CITY OF BURNABY

Re: Collingwood Village Development:
Boundary/Vanness Intersection Improvements

SUBJECT: **COLLINGWOOD VILLAGE DEVELOPMENT:
BOUNDARY/VANNESS INTERSECTION IMPROVEMENTS**

FIGURE 1
BOUNDARY/VANNESS
VANCOUVER DESIGN

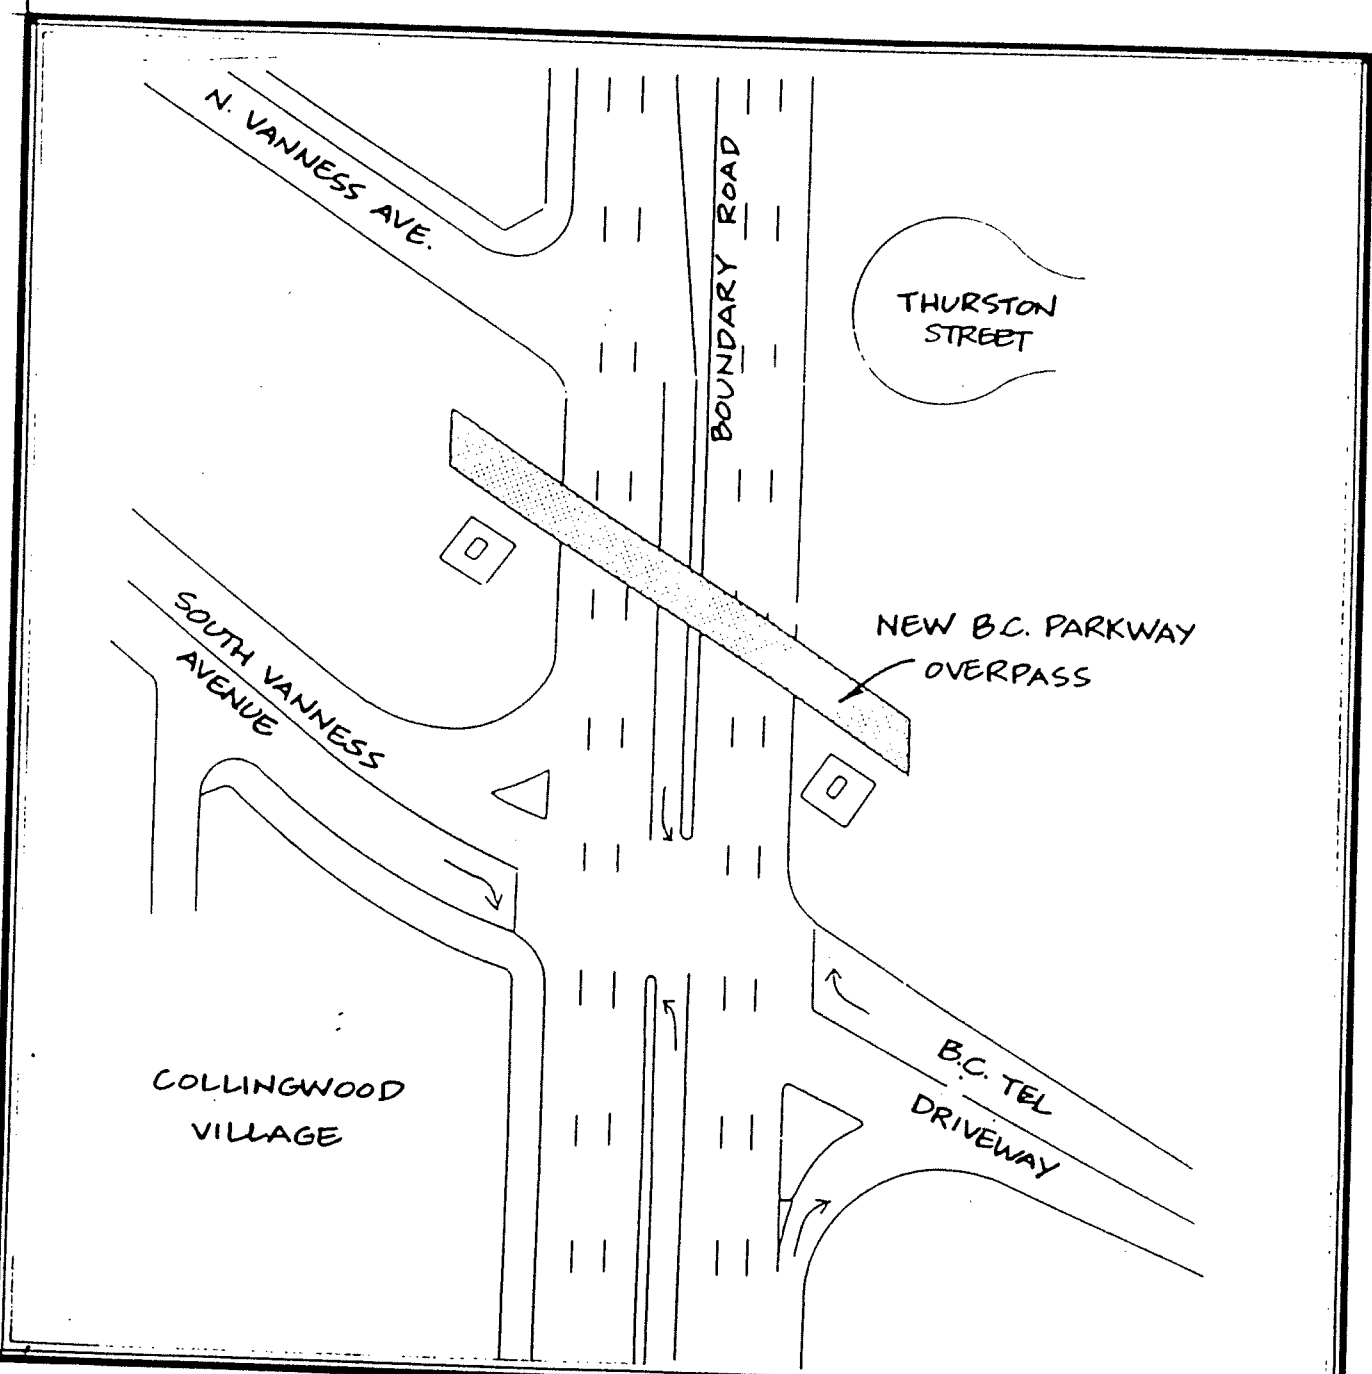
At its regular meeting of 1992 April 08 the Traffic and Transportation Committee (Transportation and Transit Division) received a report on the intersection improvements at Boundary Road and Vanness proposed by the City of Vancouver to serve the Collingwood Village Development. This intersection design as shown in Figure 1 would have involved the widening of Boundary Road to a six lane standard through removal of the rail bridge and provision for full signalization of the intersection incorporating all turning movements.

The original proposal by the City of Vancouver however did not include provision for the replacement of the rail bridge. In recent discussions however the City has agreed to include a new overpass as part of the intersection design. This overpass makes provision for pedestrians and cyclists to cross Boundary Road without the necessity for signalization to accommodate pedestrians at grade.

The original City of Vancouver proposal indicated that signalization of the intersection was required to provide for safe left turning movements via Vanness Avenue and the B.C. Telephone Headquarters driveway. The traffic study assessed the impacts of signalization out of Vanness Avenue and the B.C. Telephone building driveway. Figures 3 and 4 show the A.M. and P.M. peak hour traffic volumes making left turns at the intersection based on the Vancouver design (incorporating signalization) and the Burnaby design respectively.

- i) construction of a new pedestrian/cycling overpass to replace the rail bridge and maintain the continuity of the BC Parkway.
- ii) no signalization of the intersection
- iii) inclusion of a raised median preventing left turning movements out of either the Vanness Avenue or the B.C. Telephone Headquarters access driveway.

FIGURE 2
BOUNDARY/VANNESS
BURNABY DESIGN

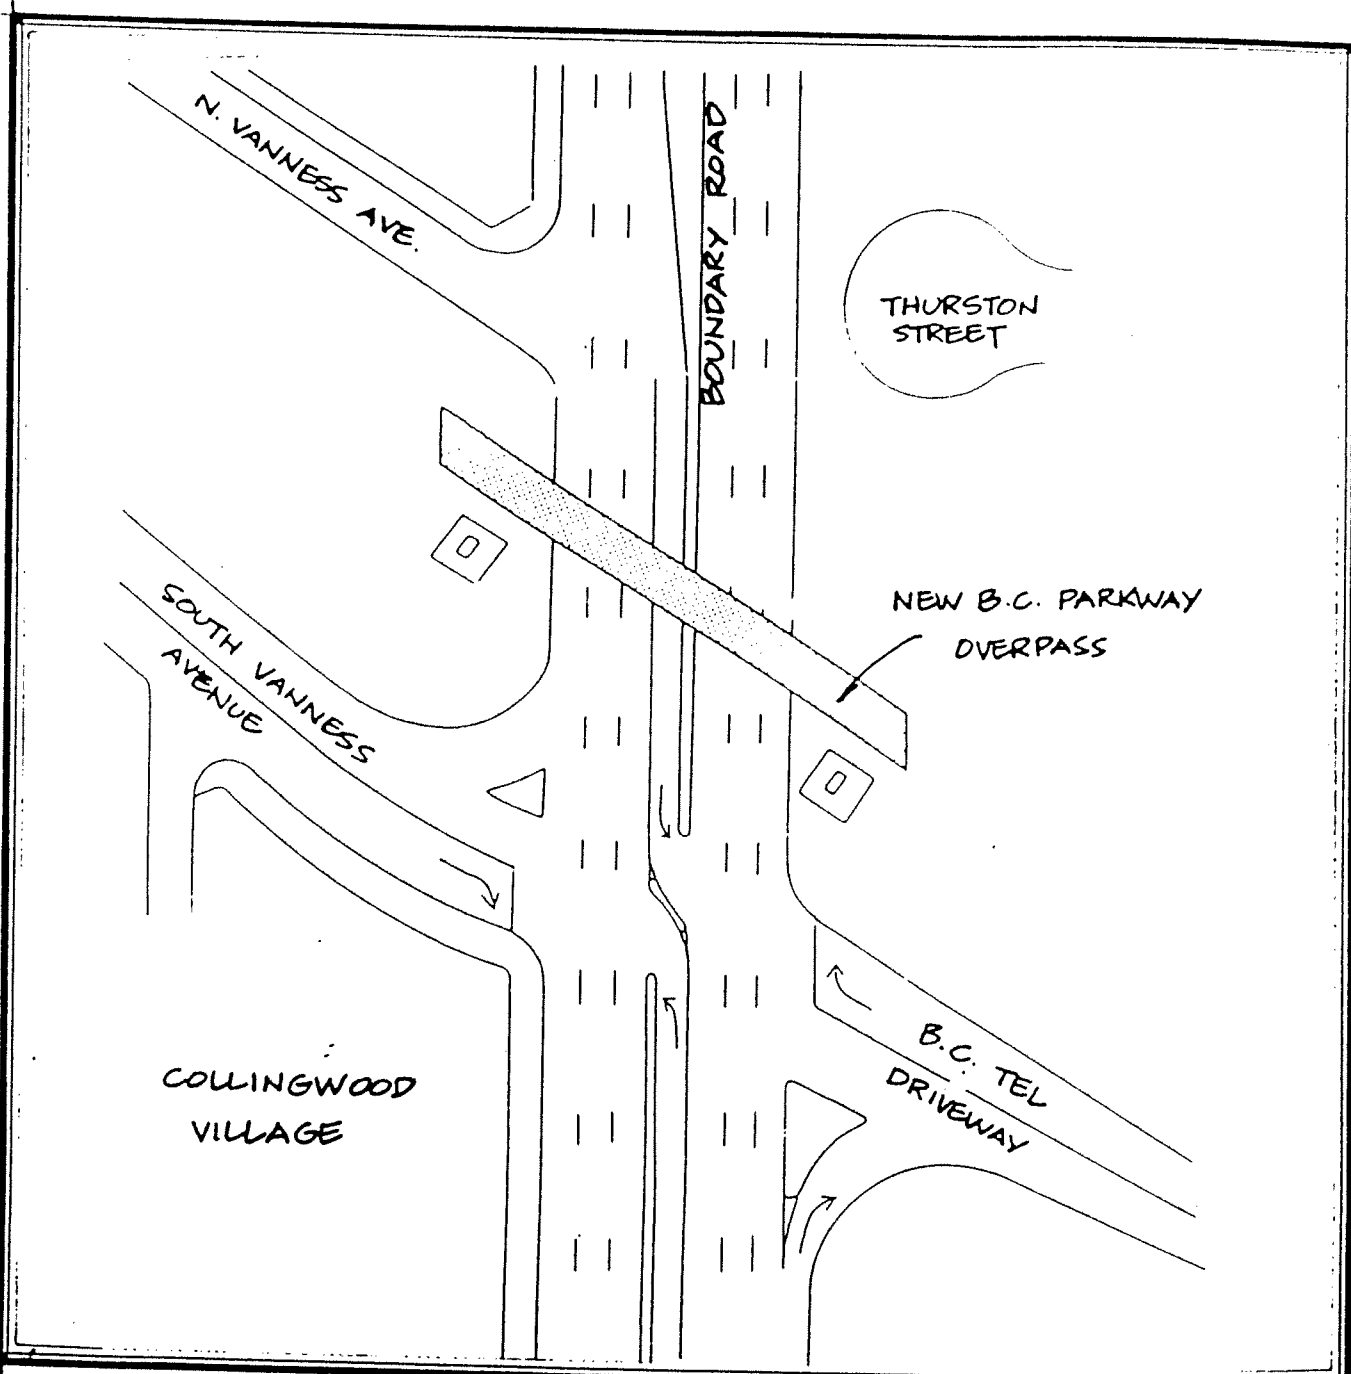
The Committee subsequently passed a motion that they did not agree with the improvements to the Boundary Road intersection as proposed by the City of Vancouver and recommended that the City be advised that Burnaby favoured the intersection configuration as illustrated in Figure 2.

On this basis staff have not been able to reach agreement on changes to the Vancouver design which would be acceptable to the City of Burnaby. It is, therefore, recommended that the Committee affirm the intersection design in Figure 2 as the design acceptable to the City of Burnaby and offer to meet with its counterpart Committee in the City of Vancouver to discuss the outstanding issues..

FIGURE 3
BOUNDARY VANNESS
PEAK HOUR
TRAFFIC VOLUMES
VANCOUVER DESIGN

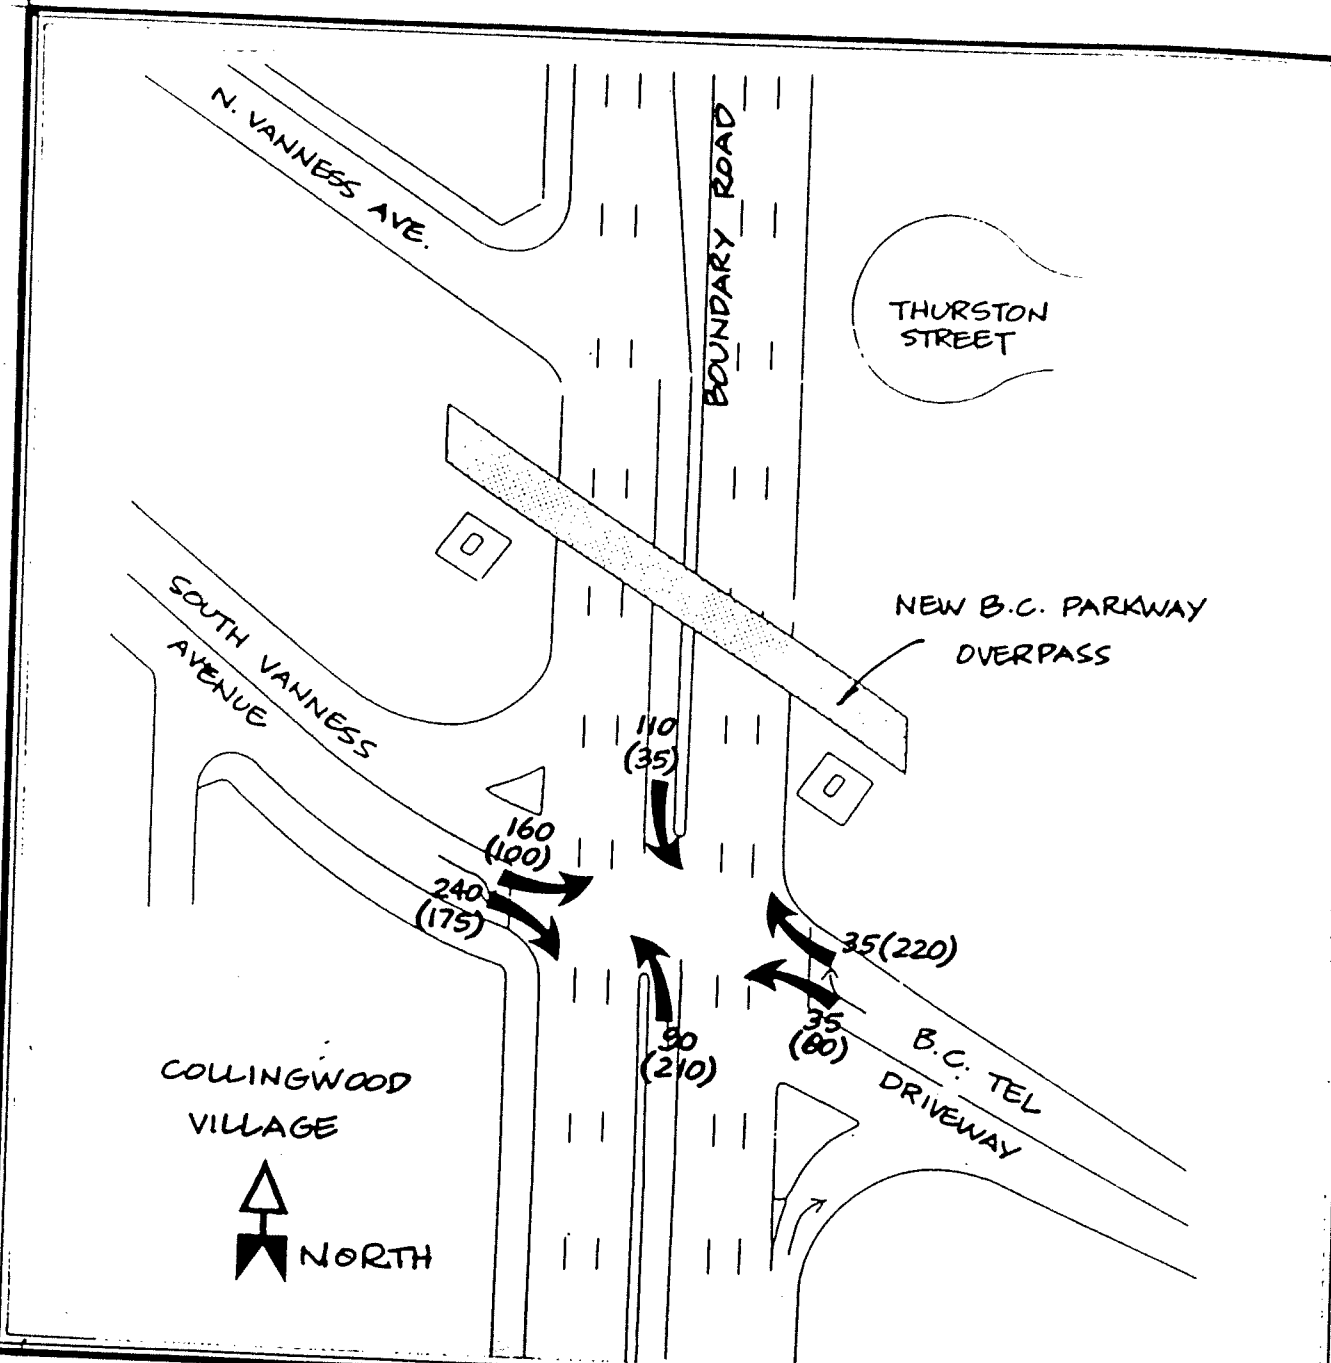
With regard to the left turn out movement the traffic study indicated that if the intersection was signalized 160 vehicles during the AM peak hour would originate from Vanness Avenue and 80 vehicles from the B.C. Telephone Headquarters driveway. (See Figure 3)
